MoDOT's I-70 Evaluation

Public Works Recommendations
September 6, 2022

Figure 4: Recommended Yellow Alternative

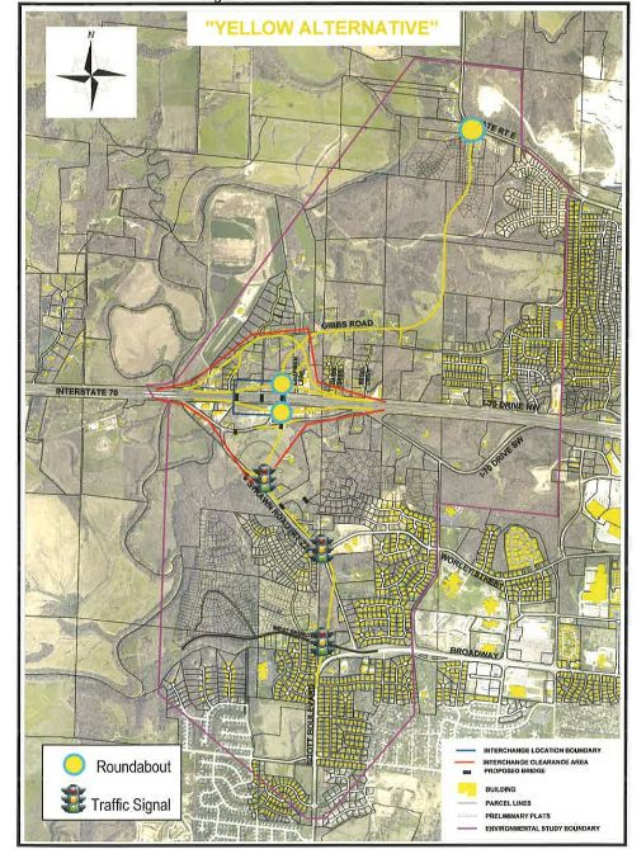
- Provides an outer road connection across Perche Creek and improves the existing outer road north of I-70
- 3 miles, 1 bridge
- Staff recommendation:
 - All proposals to date from MoDOT have appeared to specifically avoid any possibility of construction of any aspect of the Scott Boulevard interchange. The City has an FHWA approved Access Justification Report (AJR) for the interchange. Providing another connection across Perche Creek is critical for long term emergency response for both the County and City. During periods of significant delay along I-70 due to construction or significant incidents, travelers often utilize UU (MoDOT) to Gillespie Bridge Road (County and City) to Scott Boulevard (City) to access other routes around the incident backup. While relatively rare, the additional vehicle loads on City streets accelerates deterioration as well as impacting travel during those times. Another connection across Perche at this location should be a critical component of an improvement project in order for travelers on the Federal system to be able to stay on the federal system during periodic construction or incidents. The improvement should align with the findings of the AJR (see next slide, recommended AJR alternative). Another crossing of Perche is in MoDOT's Tier 3 Unfunded Needs list (page 35):

ALTERNATIVE 3
163-763
MINOR CD SYSTEM

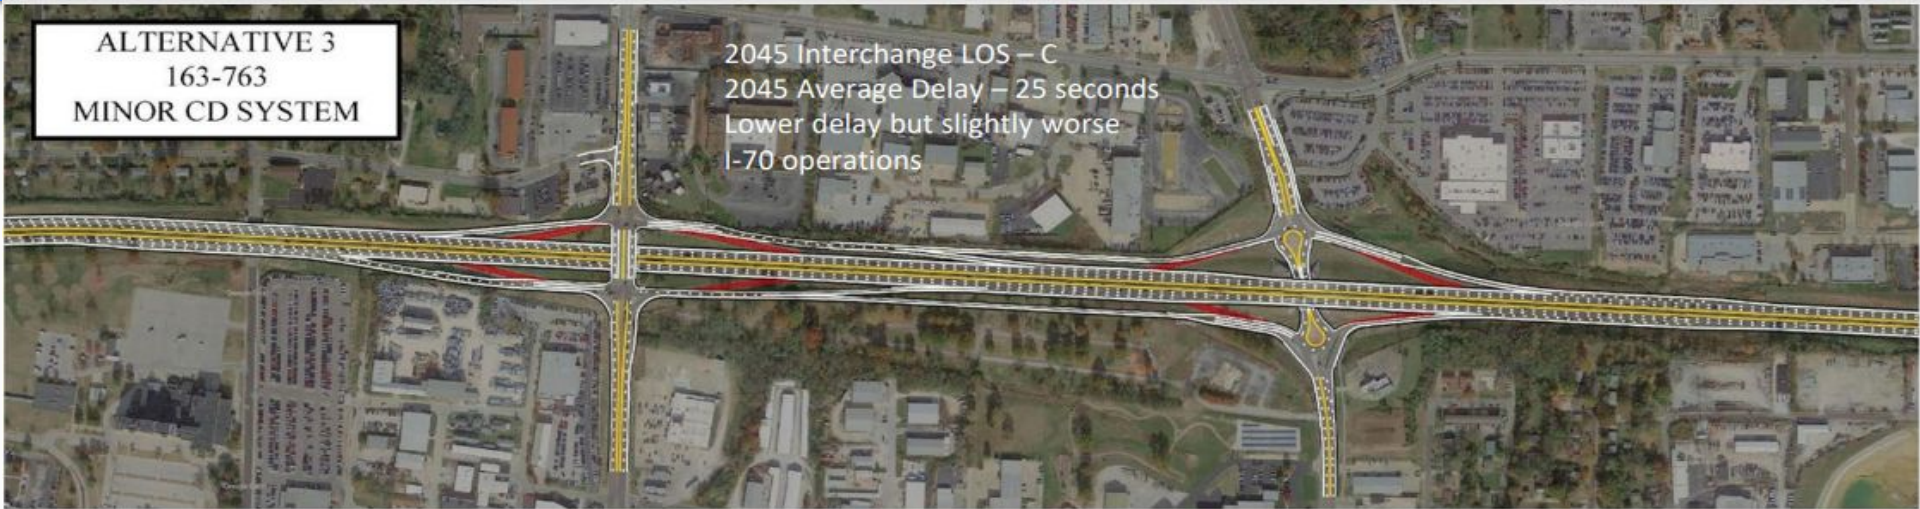
- Provides collector/distributor roads between Providence and Rangeline. The westbound off ramps and eastbound on ramps are combined, therefore Rangeline traffic to/from the west must go through the signals at Providence.
- The Loop CID's recommendation: "We do not support the addition of the north and south outer roads between Providence and Rangeline, nor the proposal to limit immediate access from I-70 to Rangeline (or vice versa). We don't believe the drivers should be redirected to the signal at Providence."
- Staff recommendation: What is proposed is consistent with access management best practices used throughout the federal highway system provided it also addresses non-motorized transportation needs.

I-70/US 63 Connector (Alternative 1)

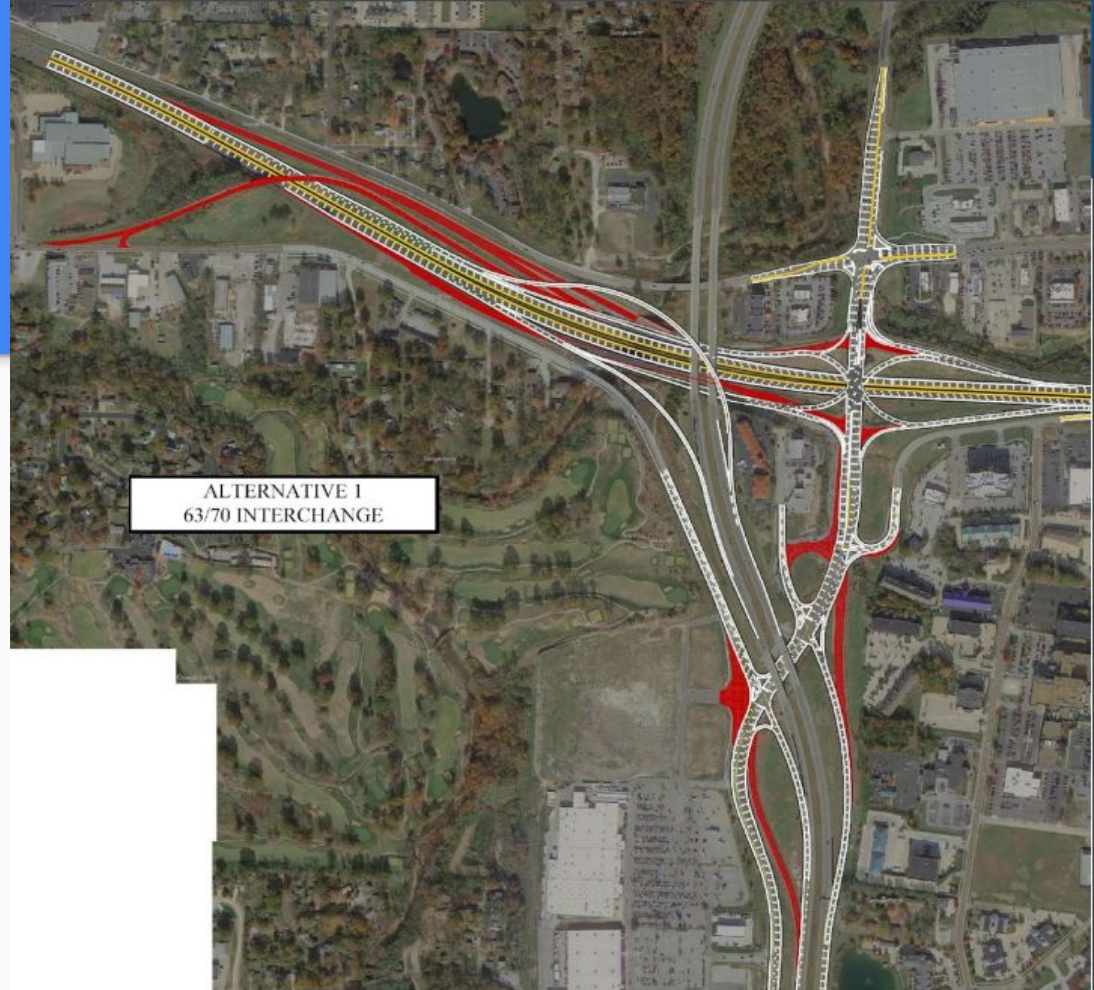
- The Loop CID's recommendation: "We will continue to review the proposals for the I-70/63 connector but again, we support long-term solutions here as well as strengthening other existing alternatives in order to relieve traffic along I-70. We would support an option that required removal of the left off ramp from I-70, especially if the Parker addition was an option.

- Staff recommendations:
 - The most recent iteration of preferred alternatives removes a signal from the City's maintenance, but creates several potential issues for City properties and roadways. It eliminates an organized entry/exit (the signal) to the Broadway Marketplace location without sufficiently addressing the volumes entering and exiting the retail location. There is no shown improvement as part of the project either north or south of the location that provides for protected left turns into or out of the shopping center. This must be addressed as part of the project.

- Staff would request that any design and eventual construction improvements to the I-70/US 63 connector include the Hinkson Creek Trail extension as it is a critical piece of non-motorized transportation to connect Columbia citizens on the north and south side of I-70. The planned route for the trail may no longer be viable depending on the selected plan for roadway improvements so Parks & Recreation staff would request to be involved with planning discussions once the roadway option is selected for the interchange. The extension of the trail is a key piece of the 30-mile trail loop through Columbia and is considered a critical connection for cyclists and pedestrians to navigate the I-70/US 63 interchange. Any improvement should directly accommodate pedestrian and cycling traffic to and through intersections per FHWA's Complete Streets Model.

Exhibit S-1 Preferred Alternative

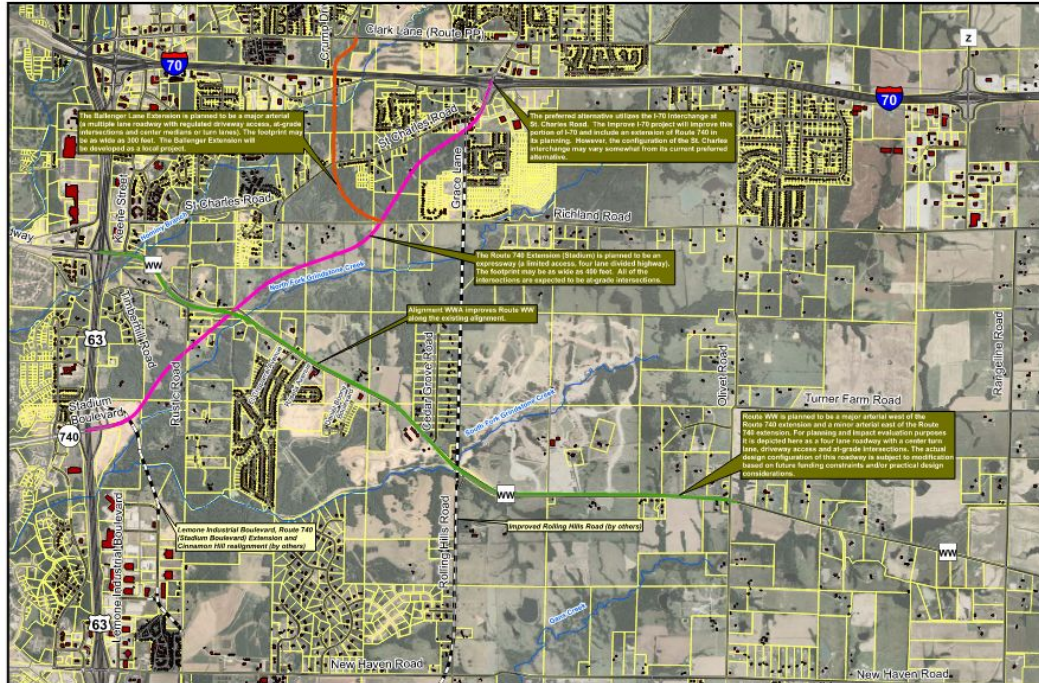
- The East Columbia Environmental Impact Statement (EIS), completed in 2009, should be updated. This will help determine long term transportation improvement needs east of US 63 including major interchange and overpass improvements for I-70. Funding for a portion of Stadium (US 63 to Route WW) is listed in Tier 3 for MoDOT's Unfunded Needs list (page 35):
<https://www.modot.org/sites/default/files/documents/2022-01%20FINAL%20High-Priority%20Unfunded%20Needs.pdf>.
